Access Compliance Report Public Rights-of-Way (Curb Ramps)

Main Street: NEWPORT_AVE		Cross Street: LA_LOMA_DR		Location:	SE
ADA ID: RPRK211008141857	Ramp Type:Type 1 - Perpendicular Diagonal Initial Pass/Fail: Fail		Overall Compliance: No	Severity Score:	15
Codes/Mitigation Info/Possible Solution			Field Measurements/Component Compliance

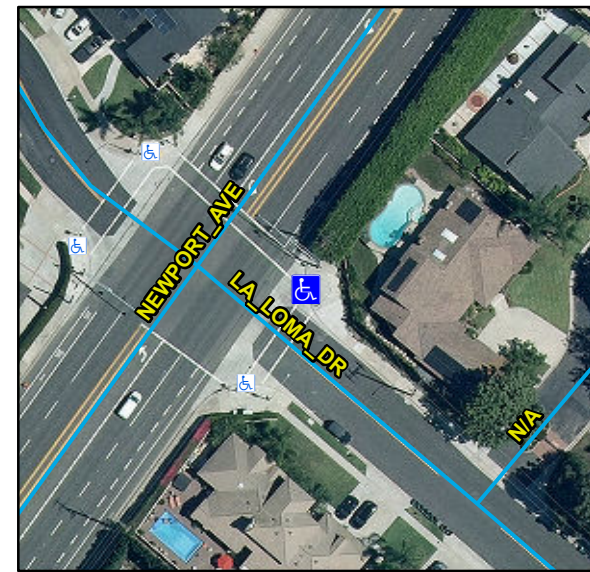
Compliance	Description	Data	Compliance	Description	Data
N/A	Ramp Length (in)	130	N/A	Flare Type LT	
Yes	Ramp Width (in)	48			N/A
No	Ramp Run Slope (%)	11.5	N/A	Flare Slope LT (%)	N/A
Yes	Ramp Cross Slope (%)	0.2	N/A	Flare Traversable LT	N/A
N/A	Landing Present	N/A	N/A	Flare Type RT	
N/A	Landing Length (in)	N/A			N/A
N/A	Landing Width (in)	N/A	N/A	Flare Slope RT (%)	N/A
N/A	Landing Run Slope (%)	N/A	N/A	Flare Traversable RT	N/A
N/A	Landing Cross Slope (%)	N/A	N/A	DWS Provided	N/A
N/A	Landing Movement Obstructed?	N/A	N/A	DWS Contrast	N/A
	Landing Movement Type	N/A	N/A	DWS Length (in)	N/A
N/A	Landing Shared	N/A	N/A	DWS Full Width	N/A
N/A	Clear Space	Yes	N/A	DWS Offset Left (in)	N/A
N/A	Clear Space To Crosswalk (in)	48	N/A	DWS Offset Right (in)	N/A
N/A	Marked Crosswalk 1	Yes	N/A	Marked Crosswalk 2	Yes
	Crossing 1 Direction	NW		Crossing 2 Direction	SW
	Marked Crosswalk 1 Width (in)	100		Marked Crosswalk 2 Width (in)	100

N/A	Ramp Inside Crosswalk 1	Yes	Yes	Ramp Inside Crosswalk 2	Yes
	Crossing 1 Slope (%)	10.5		Crossing 2 Slope (%)	0.4
	Crossing 1 Cross Slope (%)	4.6		Crossing 2 Cross Slope (%)	0.2
N/A	Gutter Ponding	N/A	No	Curb Slope	16.9
Yes	Gutter Lip Height (in)	0		Road Run Slope (%)	2.4
N/A	Gutter Run Slope (%)	N/A		Road Cross Slope (%)	6.3
N/A	Gutter Cross Slope (%)	N/A			
Yes	Overall Surface Condition: Acceptable		Yes	Perp Joint Present	Yes
	Cross Gutter Present?	No		Spandrel Present?	No
	Replace Cross Gutter?	N/A		Replace Spandrel?	N/A

Remove & Replace Curb Ramp With Two New Directional Ramps or Equivalent.

R304.2.2, STD 1115
